Please find a submission attached re: 25 Aranda Dr, Davidson - DA2025/0401

DEVELOPMENT APPLICATION DA (DA2025/0401) ALTERATIONS AND ADDITIONS TO A DWELLING HOUSE INCLUDING A SWIMMING POOL 25 ARANDA DRIVE, DAVIDSON

Image 1: Site plan indicating private open space areas of No. 23 Aranda Drive

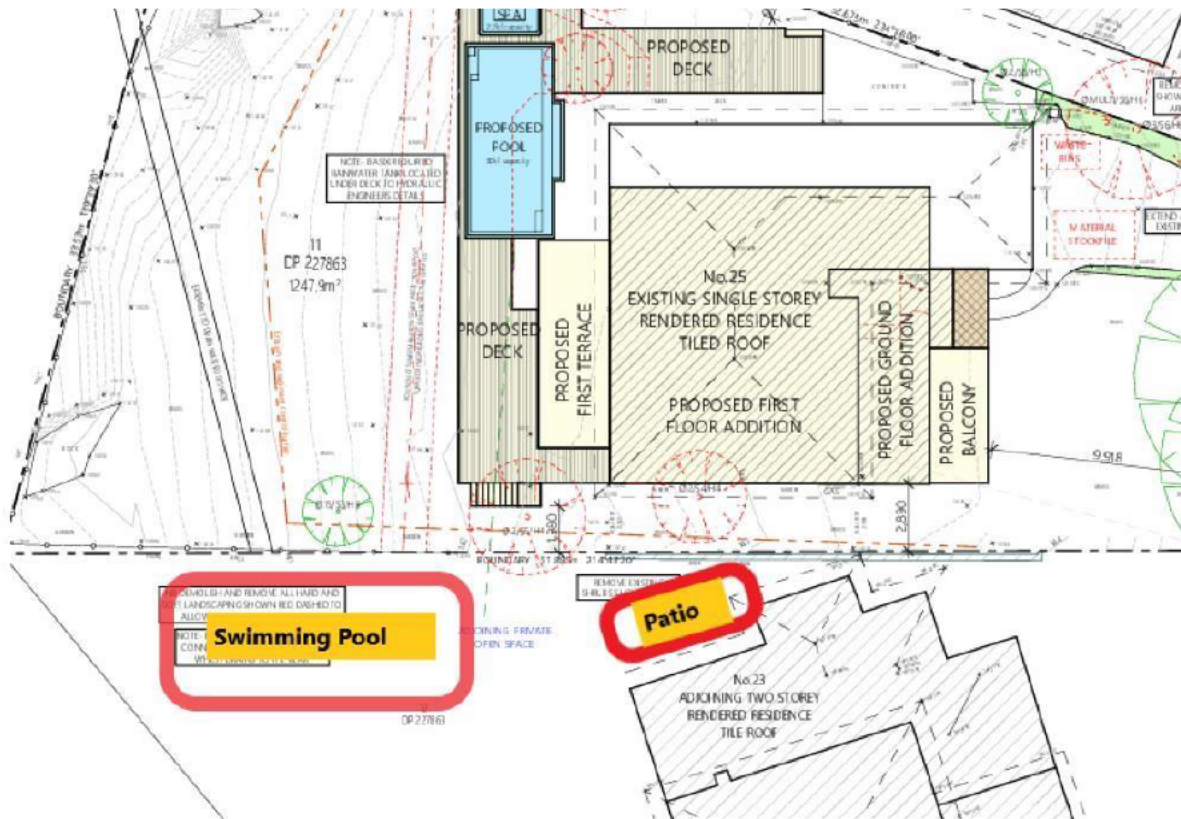
Concern is raised with regard to privacy impacts with the proposed alterations and additions. My client has a swimming pool and patio area adjacent to the common boundary which is identified below:

The development seeks to provide a large deck with pool incorporated which will be raised above ground level. The deck will also provide stairs adjacent to the common boundary down to the rear yard. My clients have a swimming pool that will be overlooked by the large deck and terrace proposed and raises visual privacy concerns.

It is considered that the portion of deck to the east, accessed from the rumpus room, is superfluous to the needs of the occupants regarding the amount of private open space required for the home. The dwelling will provide an abundance of decking areas directly accessed from the main living area in association with the pool that the eastern area of decking is superfluous and creates privacy impacts.

We seek that this portion of deck be deleted or significantly reduced in scale. Alternatively, the decking could be split levelled to lower the deck to be closer to existing ground level to minimise overlooking concerns.
